TOWN OF BAY HARBOR ISLANDS
DEVELOPMENT & REVIEW COMMITTEE MEETING
RESCHEDULED, TUESDAY, NOVEMBER 15, 2022

1. Review and discussion of Site Plan Application by PPG BHT Owner, LLC to construct a 44-unit Multi-Family Development to be located at 10143 East Bay Harbor Drive. Enclosed are the Site Plans and the Staff Report prepared by Town Planner Michael Miller.
2. Review and discussion of Site Plan Application by CHBH 103rd Street, LLC, to construct a 77-unit Multi-Family Development to be located at 10200-10290 East Bay Harbor Drive. Enclosed are the Site Plans and the Staff Report prepared by Town Planner Michael Miller.
3. Review and discussion of Site Plan Application by DDG 1055 BHI, LLC, to construct a 9-unit Multi-Family Development to be located at 1055 93 Street. Enclosed are the Site Plans and the Staff Report prepared by Town Planner Michael Miller.

**TOWN OF BAY HARBOR ISLANDS
COMMUNITY DEVELOPMENT
MEMORANDUM**

Subject: Site Development Plan Application – DRC Review #3
Proposed New Multiple-Family Development (44 DU)
Existing Bay Harbor Tower Site (30 DU)
10141-10143 East Bay Harbor Drive
Bay Harbor Islands Acct. No. SPR22-000024
MMPA Acct. No. 01-0702-1142

A-12A

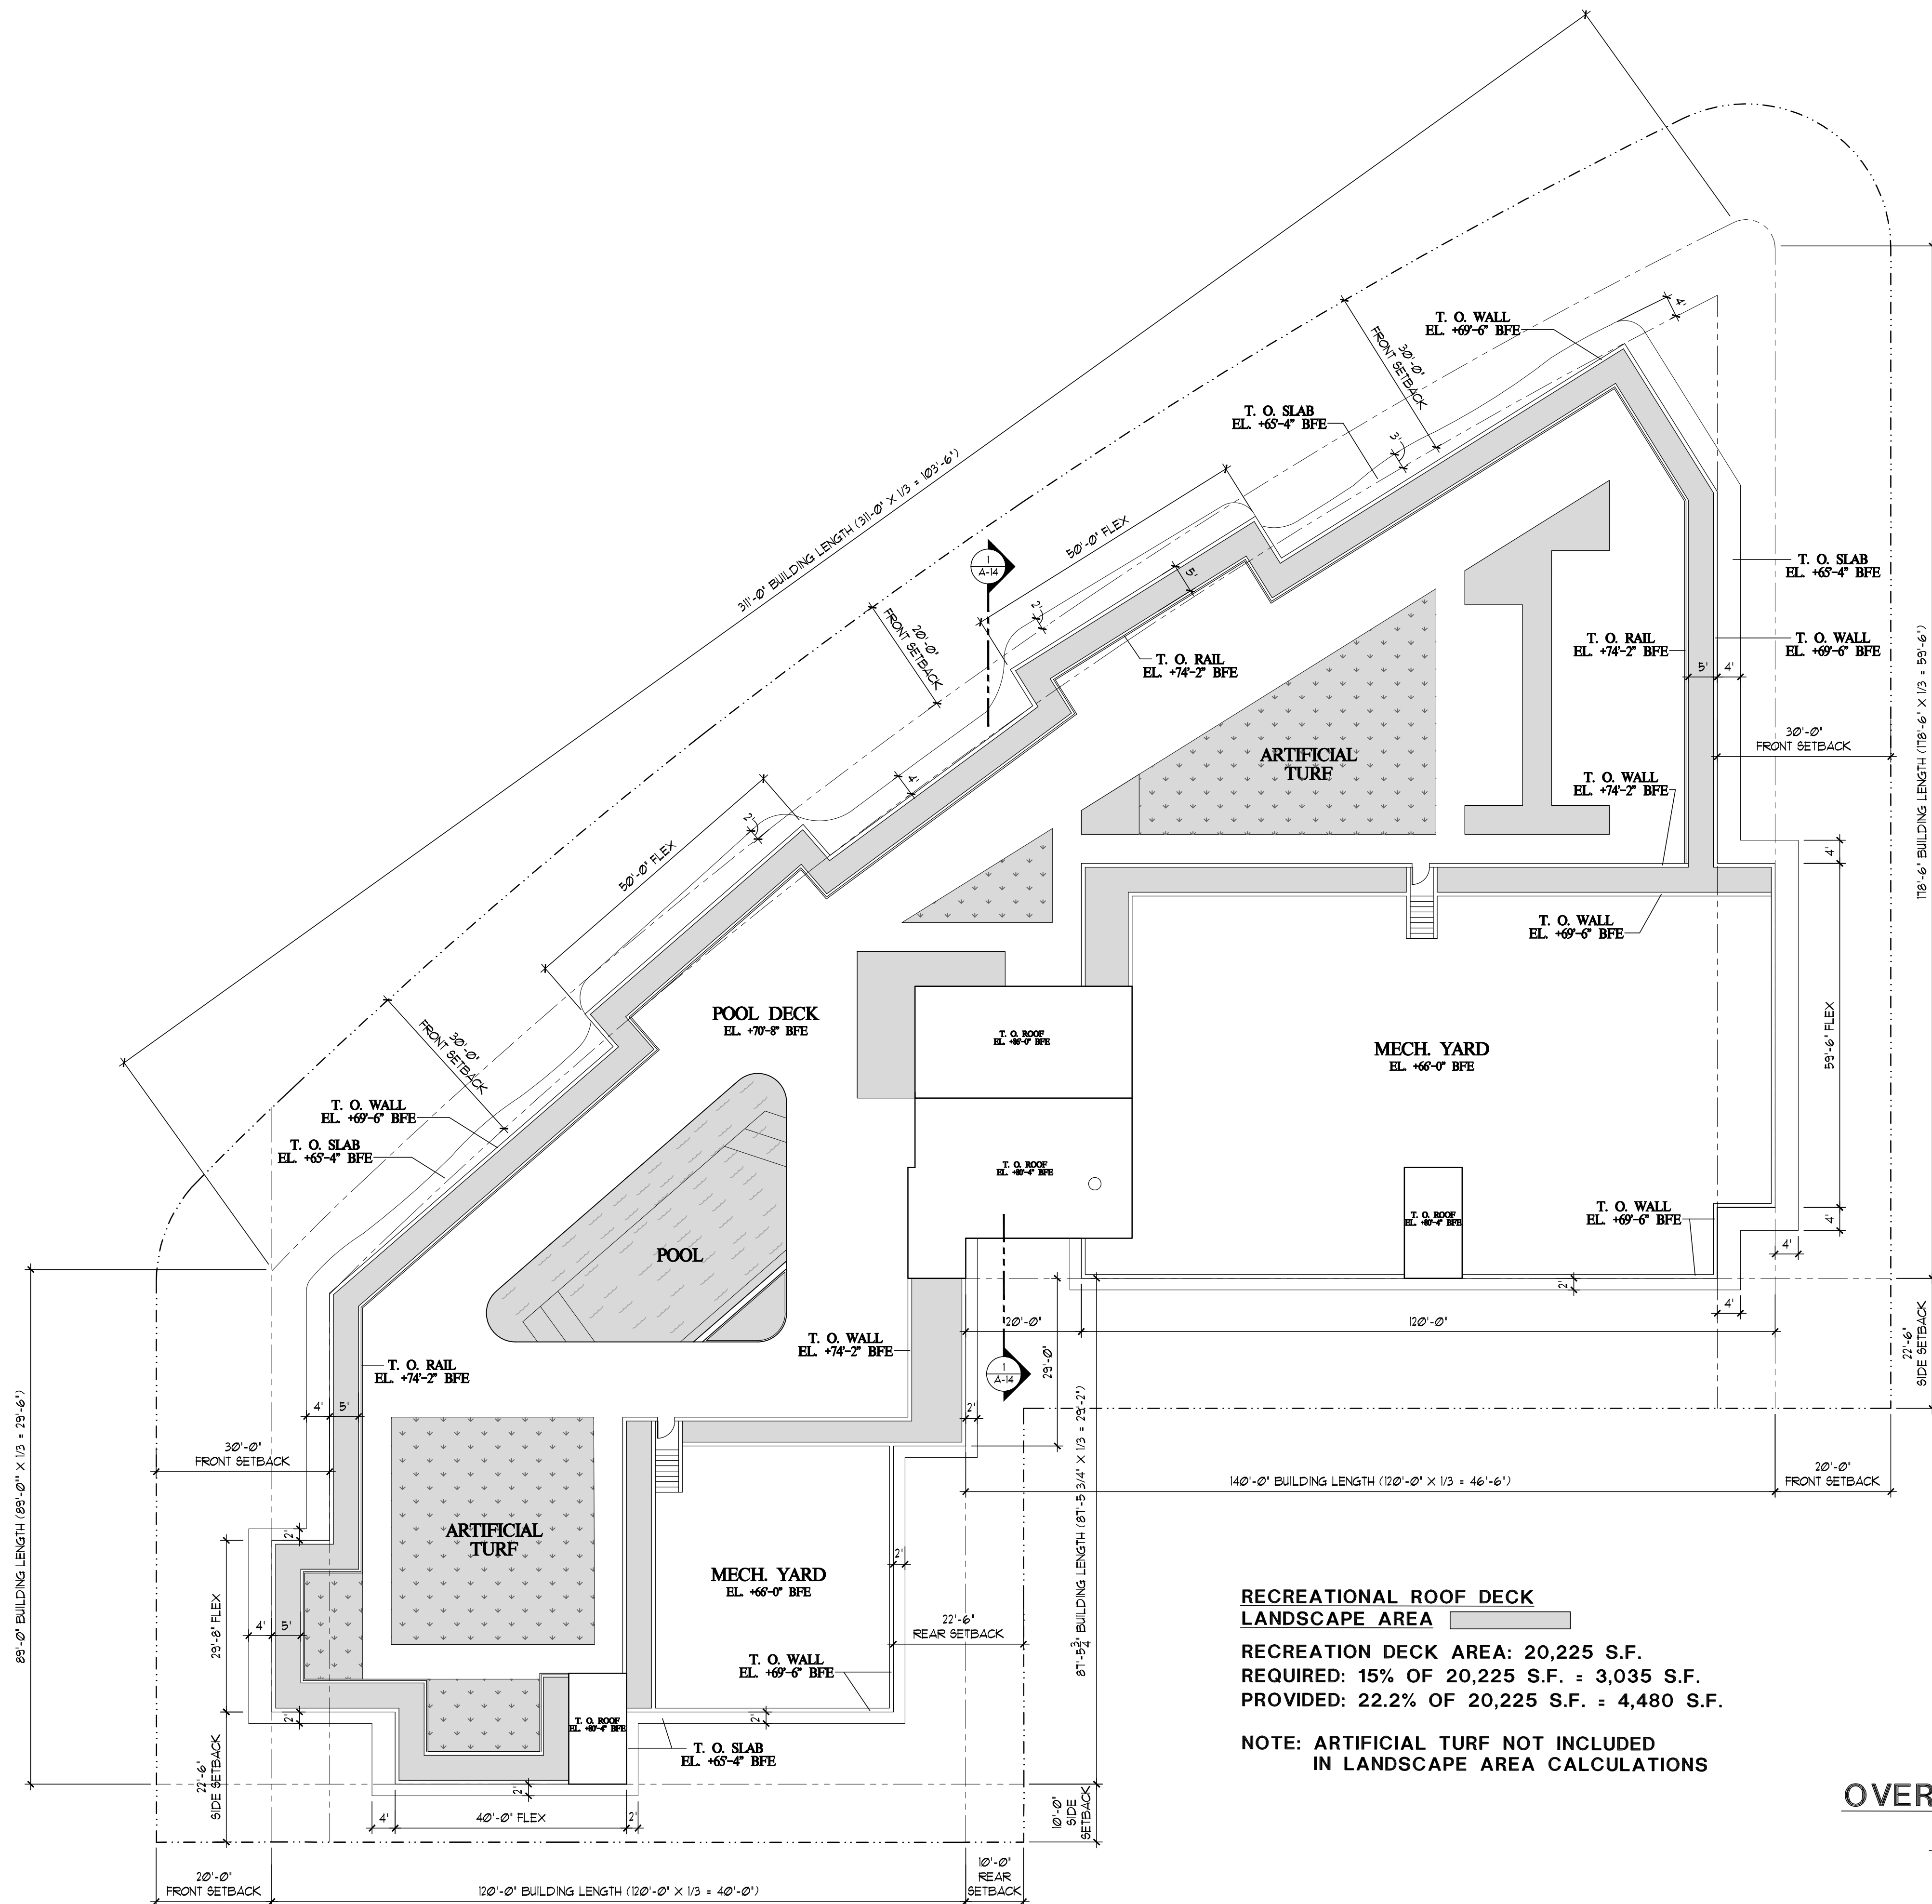
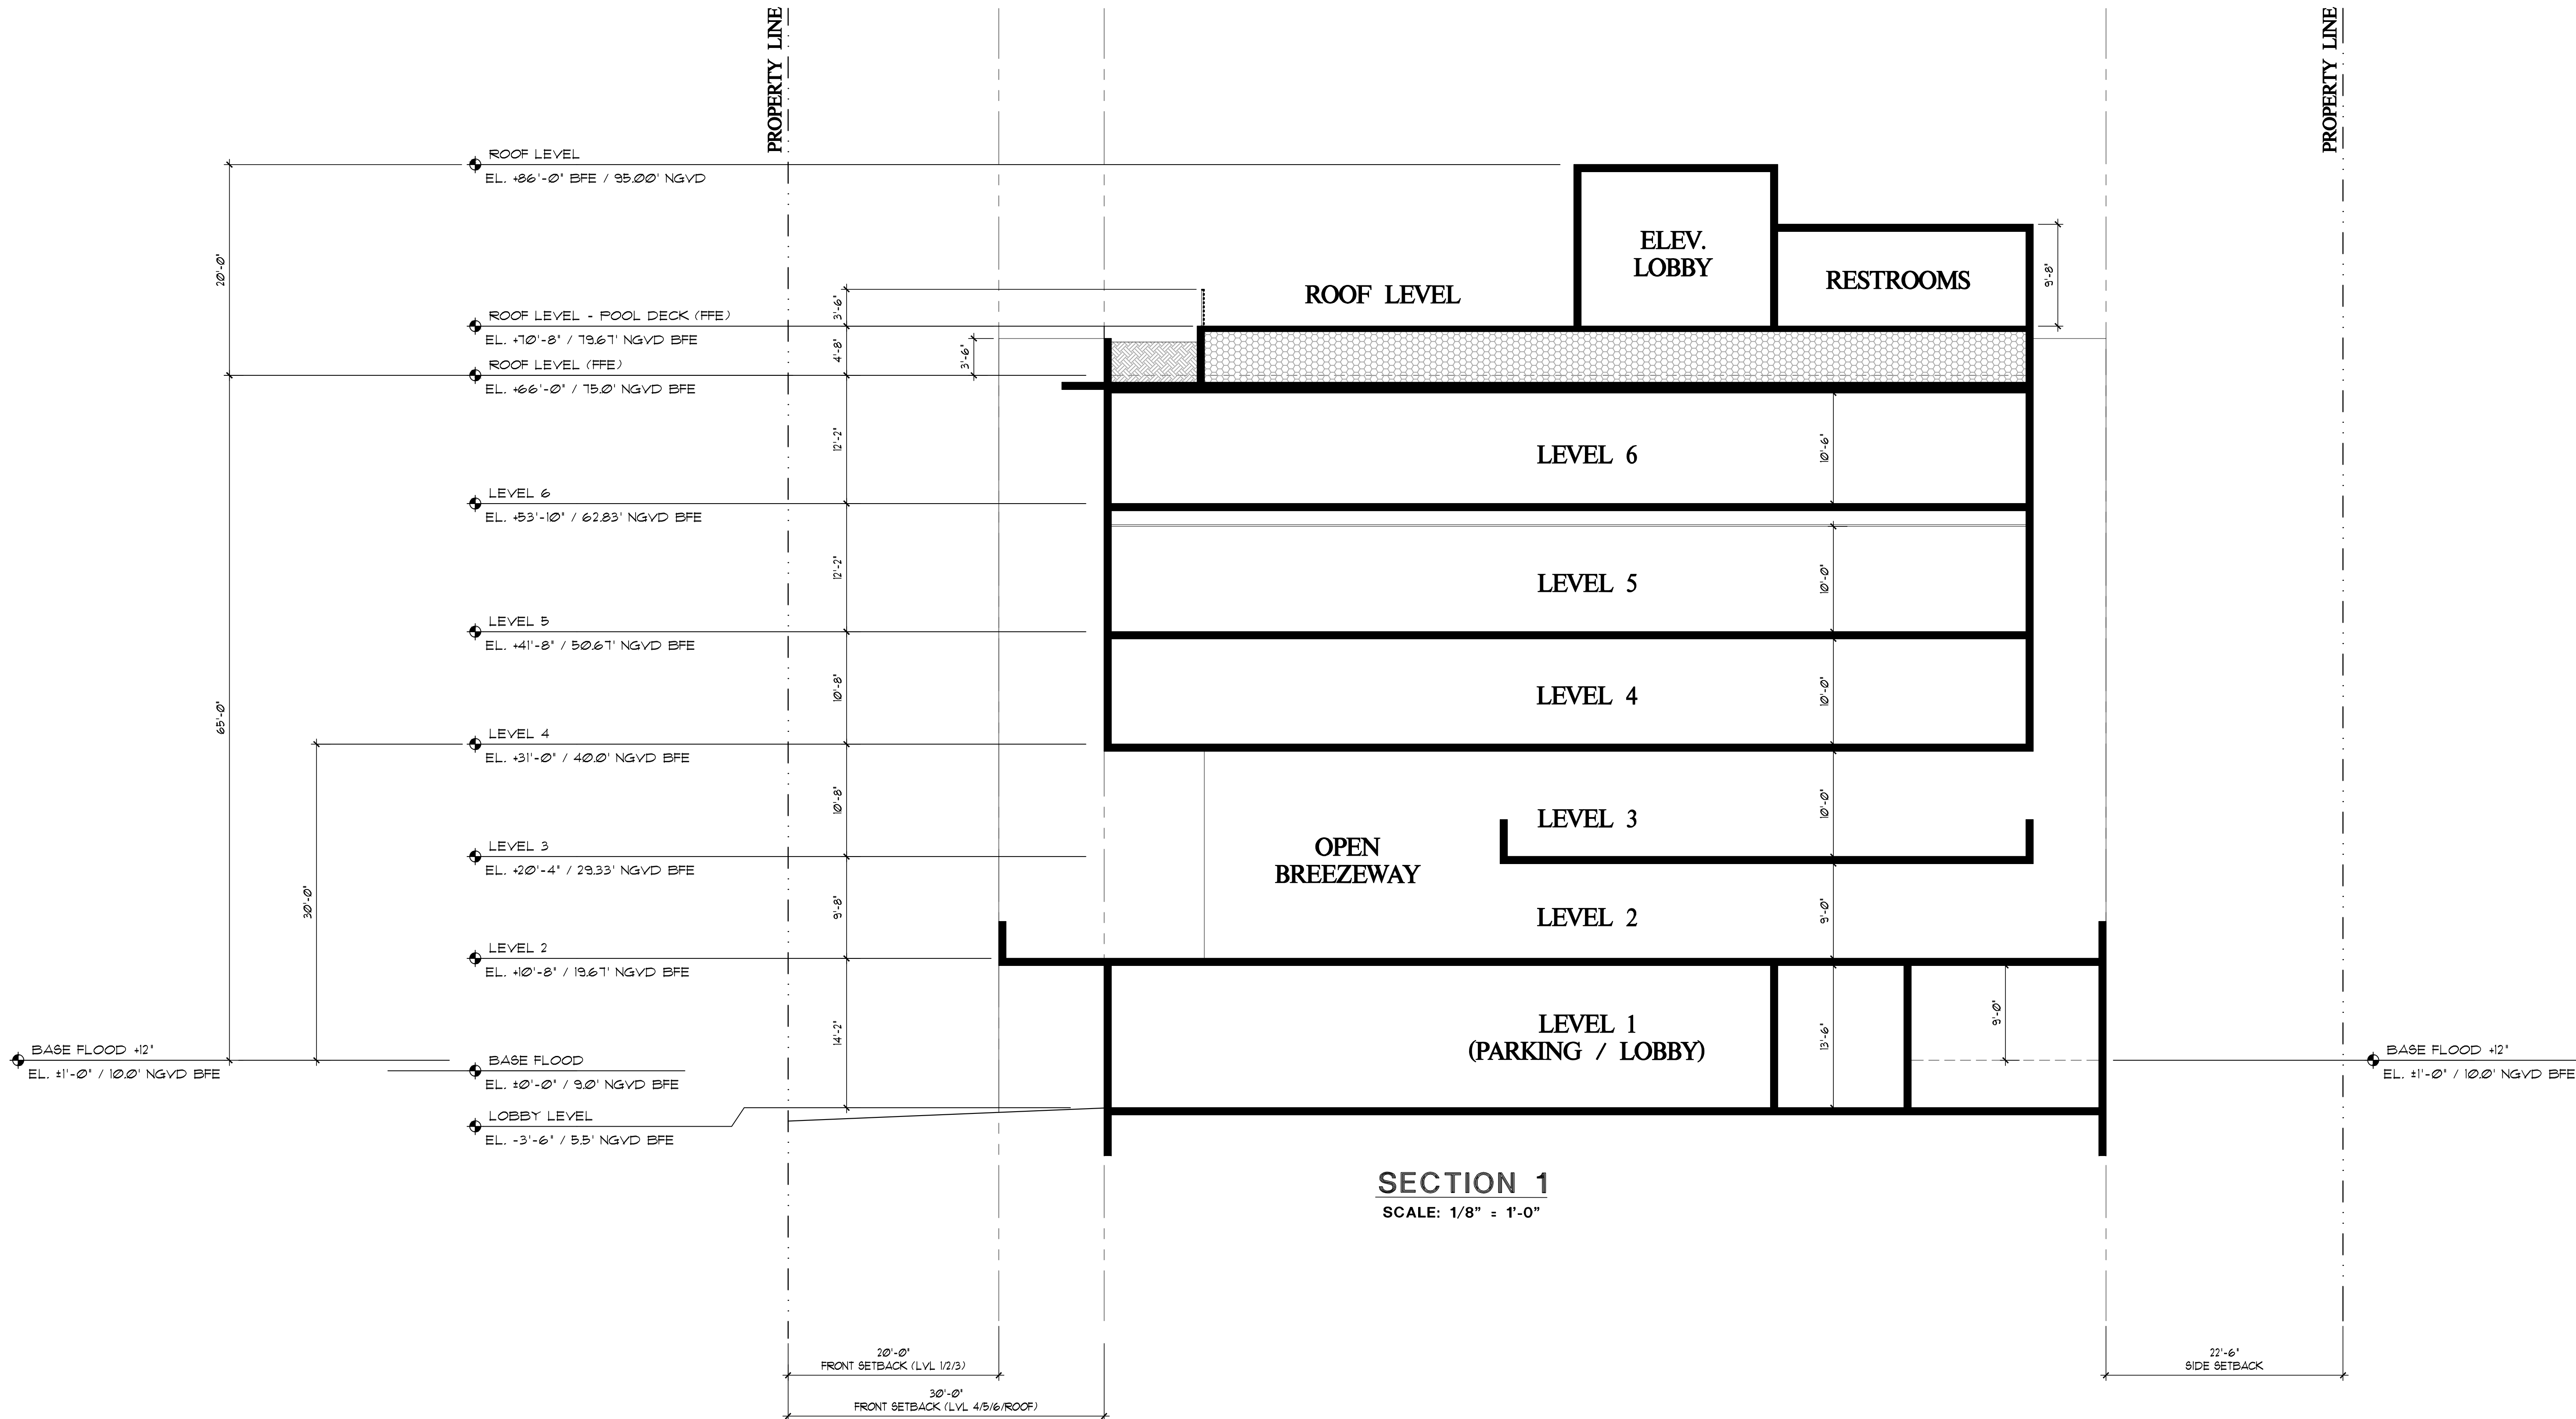
24. On Sheet A-12 there are no height dimensions noted for the numerous rooftop accessory structures. The maximum height allowed is 20' for elevator overrides / stairs and 10' for shade structures / canopies / trellis measured from the main roof deck. Parapet walls / etc. are limited to 5' in height above the main roof deck. Any raised decks for a pool / pool deck must be setback at least 5' from the edge of the main roof. See Sec. 23-12(25).

Response: Additional information has been added to Sheet A-12. In addition, Sheet A-12A has been added to show the heights of the elevator shafts, stair shafts, etc.
